Two Power Mosfets (FQP30N06L) and associated current limiting circuit. Limits current to ~300ma
<https://www.instructables.com/id/Circuits-for-using-High-Power-LED-s/>
 ...got base wrong on first board

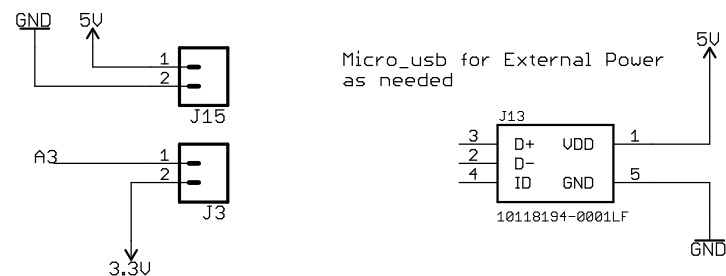
02/04/19 - fixed base on power resistor transistors
still need to fix Q4 transistor should be EBC
